Job No. 198337

Re: Response to Review Comments
Antelope Ridge at Bull Hill, Phase 1
Bradley Rd
El Paso County, Colorado

Re: Addendum to Soils and Geology Study
Antelope Ridge at Bull Hill, Phase I
El Paso County, Colorado
PCD File No. PUDSP255

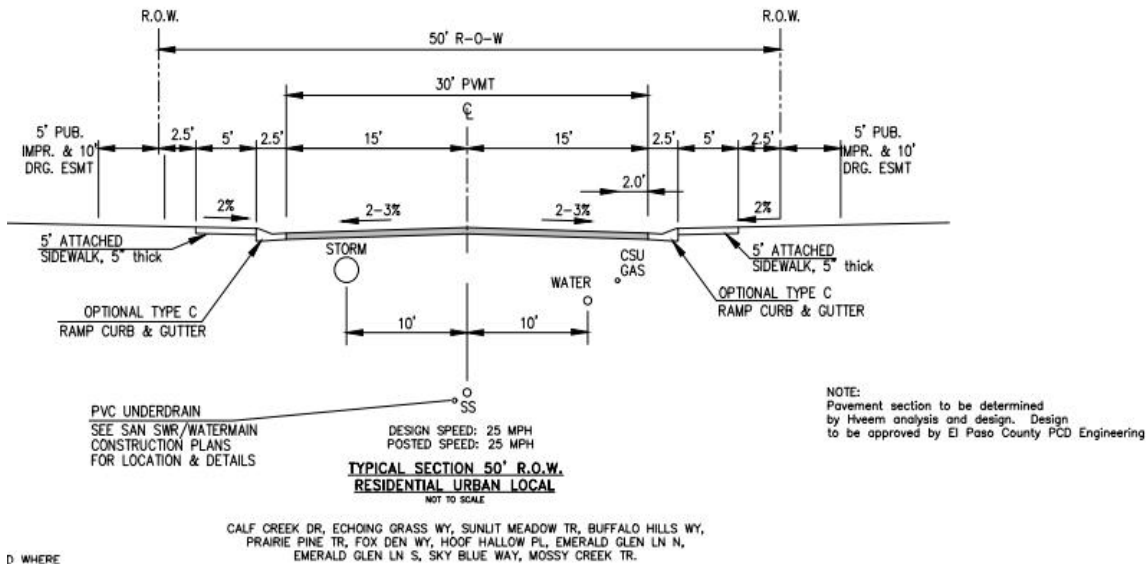
Provide a detail for underdrain system

Add the following (as long as the Design Engineer and the Developer meets Colorado State requirements and indicate the district name responsible for the maintenance); please see plat note indicated below.

Core Engineering Group has provided the construction plans for the passive underdrain system for Antelope Ridge, at Bull Hill, Phase 1. It is our understanding the passive underdrain system is to be located 1-foot below the sanitary and stub out to every lot. The outlets for the underdrain system daylight into the E. Tributary, south of the project. Below is a snippet of the Street / Storm Typical Sections as presented in Core Engineering Group's detail (Project No.100.302, sheet C1-3, dated

TEST BORING
LOCATION PLAN

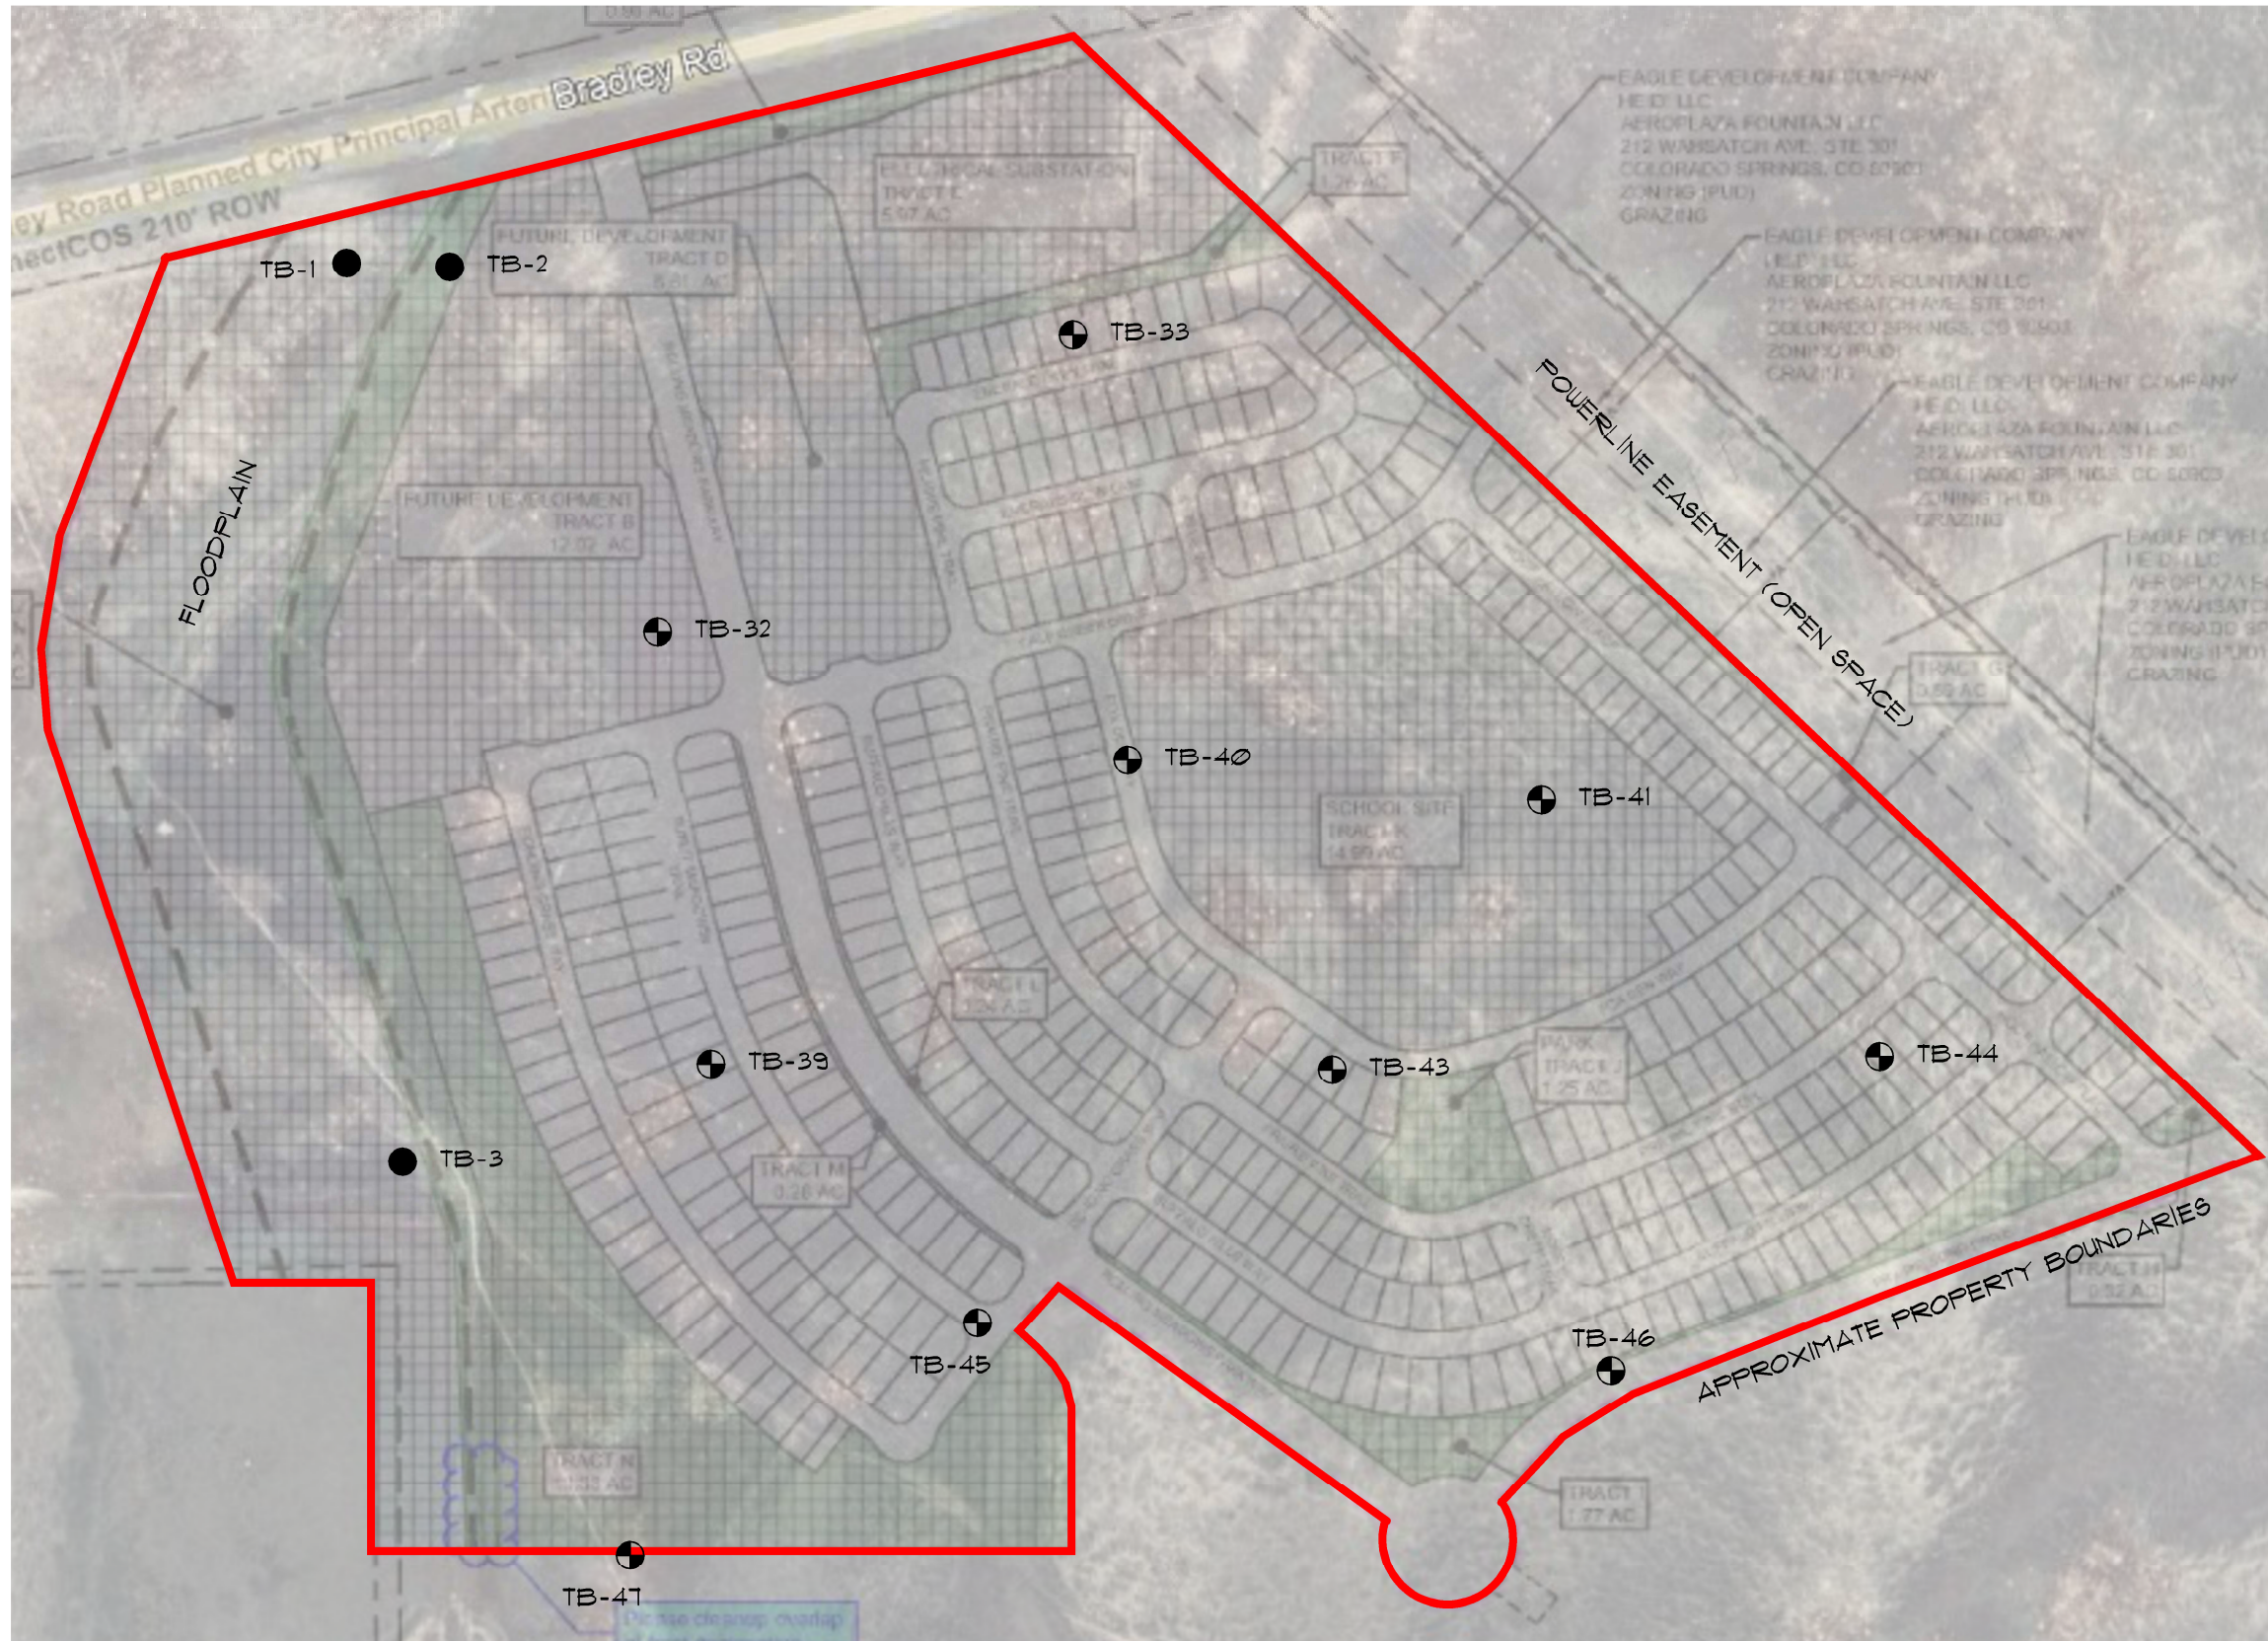
PHASE 1 AND 10
 Please provide a clear figure showing all three test borings. If TB-2 is near the proposed pond, that could indicate potential for groundwater flow into the pond which would require mitigation. It is hard to tell without a figure that is clear where the borings are and the potential for this impact.
 It is not mentioned in the 3 test borings performed for this report, at the time of

The amended report dated December 5, 2025 has been updated to reflect the additional requests. As for the comment on the location of TB-2, it is not located within a proposed pond per the Planned Unit Development provided by Matrix, last dated August 2025. TB-2 was located near

Jimmy Camp Creek within the floodplain in Tract B designated for future development. A clearer Test Boring Location Plan, Figure 2 is included in the amended report.

SHEET No.
FIG-11

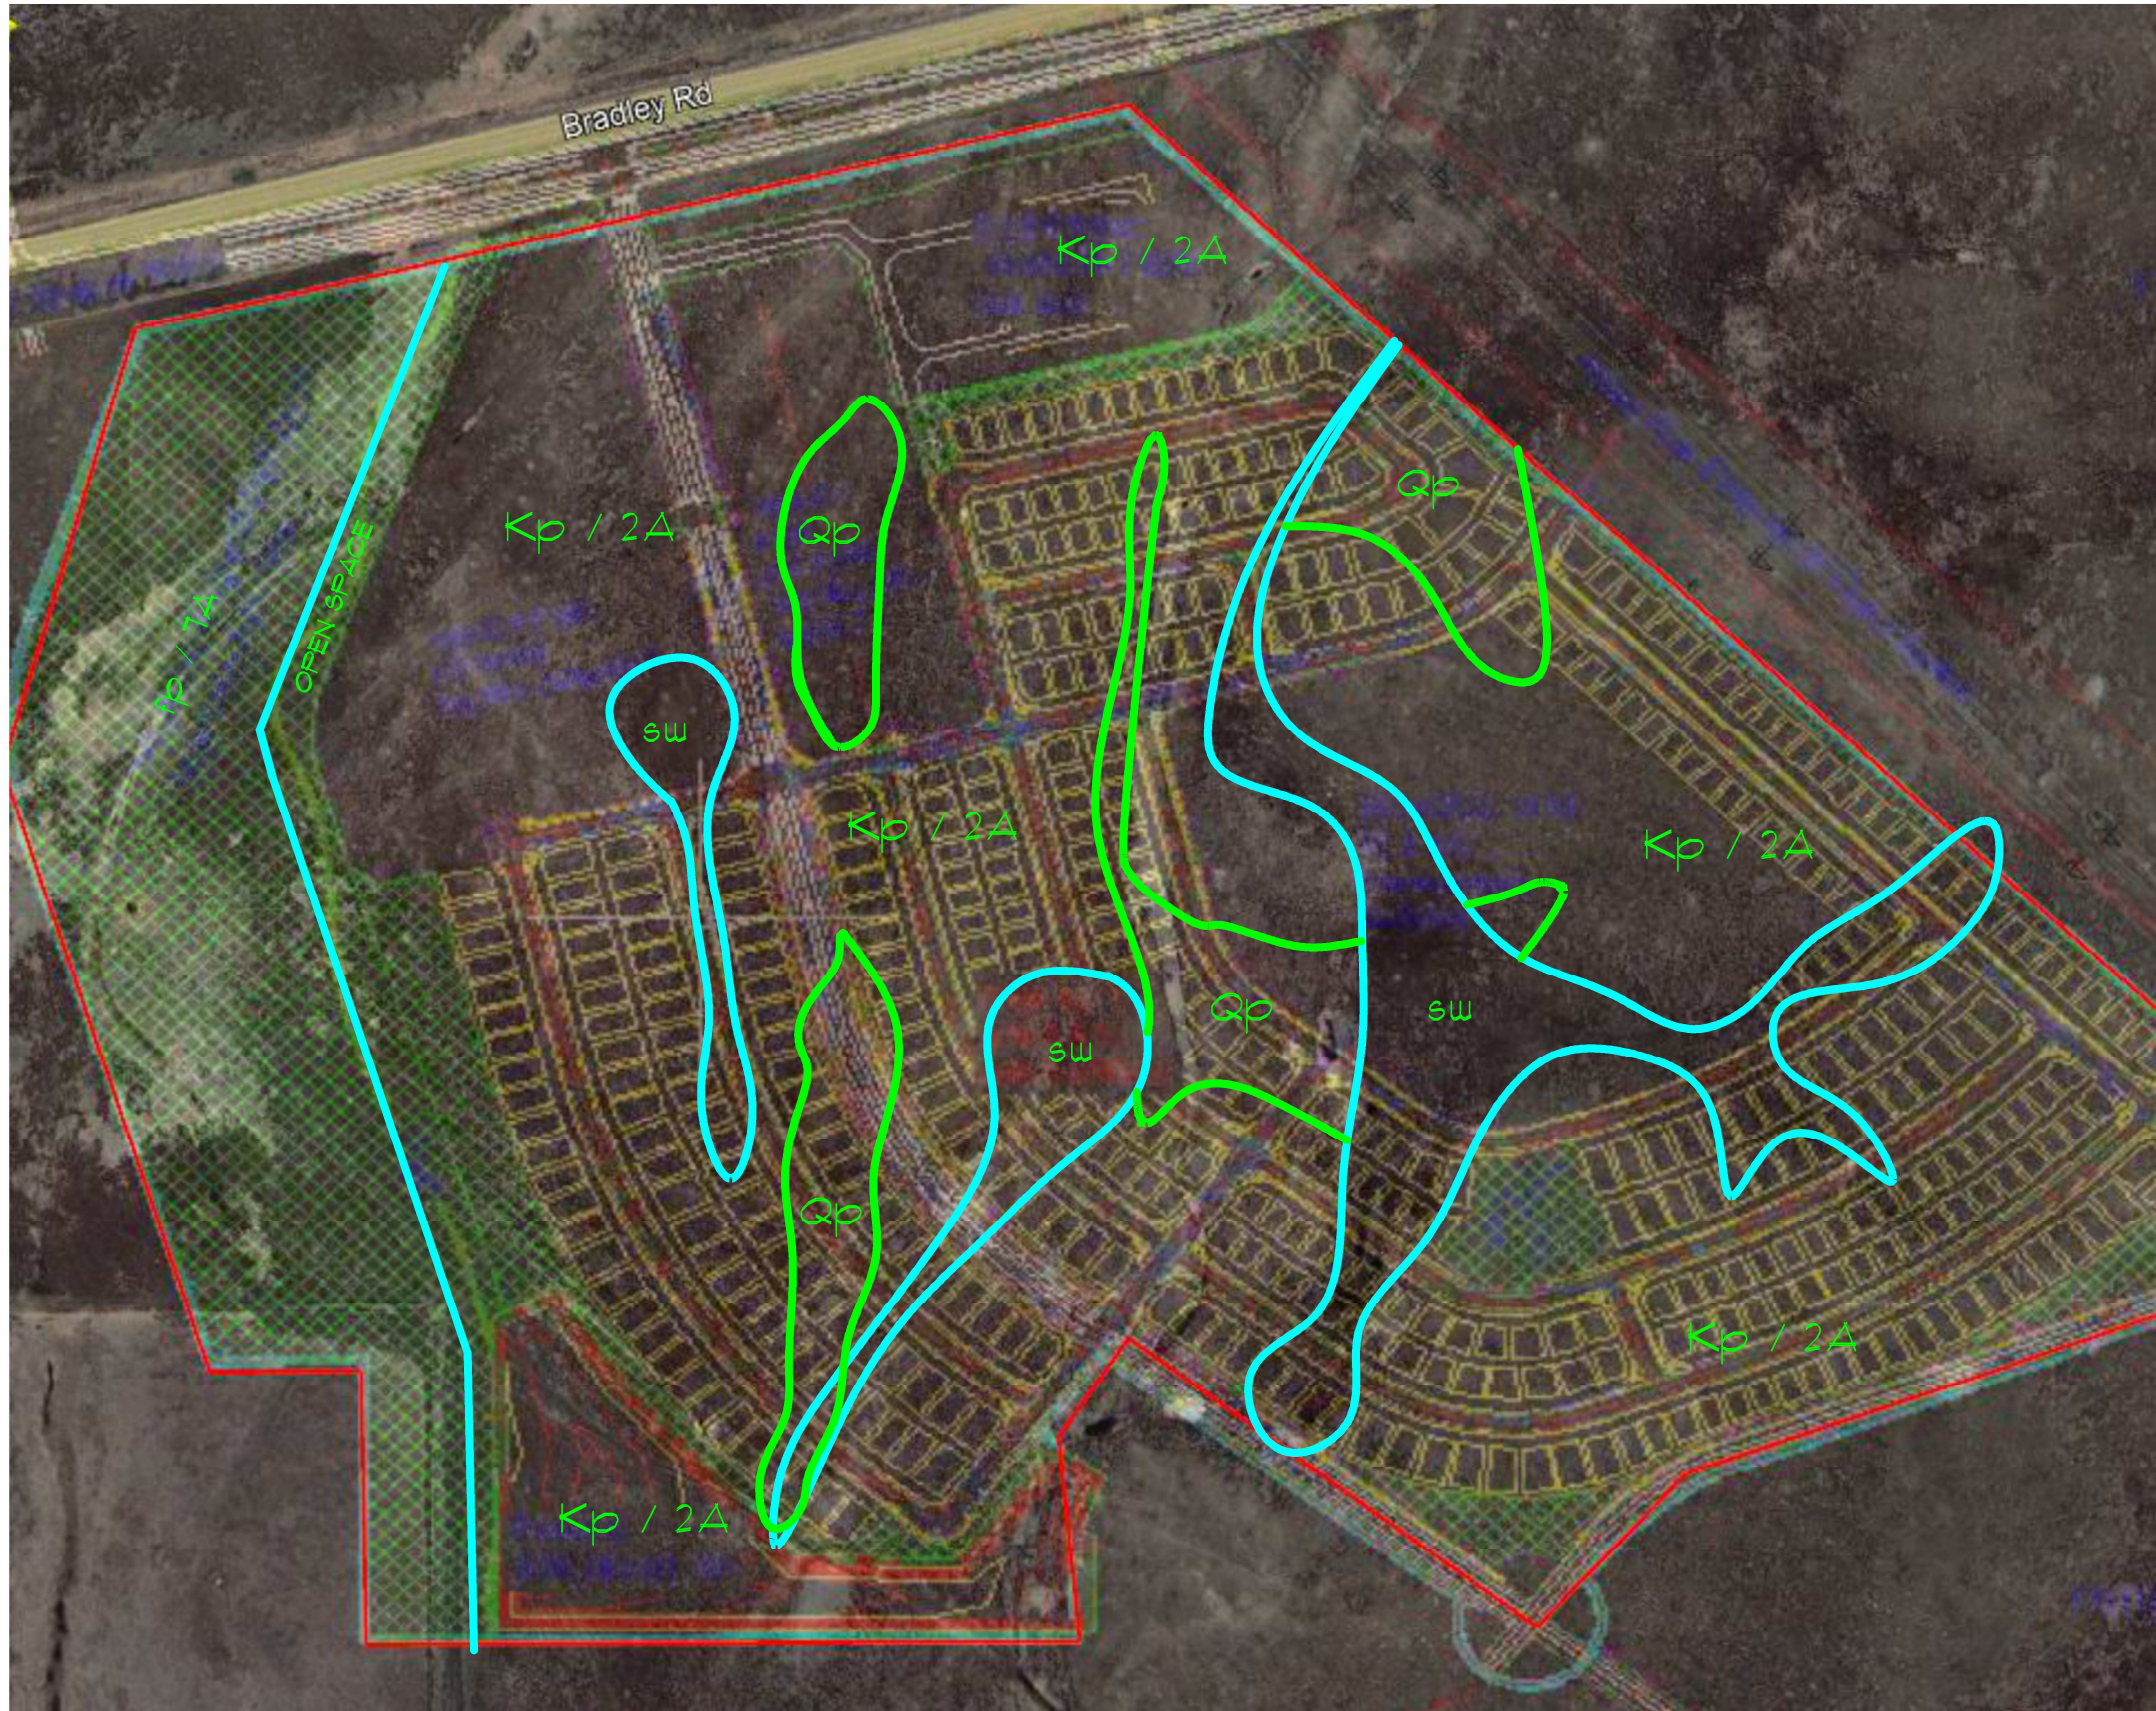
Provide a map showing geologic hazards & constraints.

Figure 11, Engineering and Geology Map was included in our report last dated March 14, 2025 and shown below. It is uncertain if the Figure was missed or insufficient. If insufficient we would request further explanation as to what is needed.
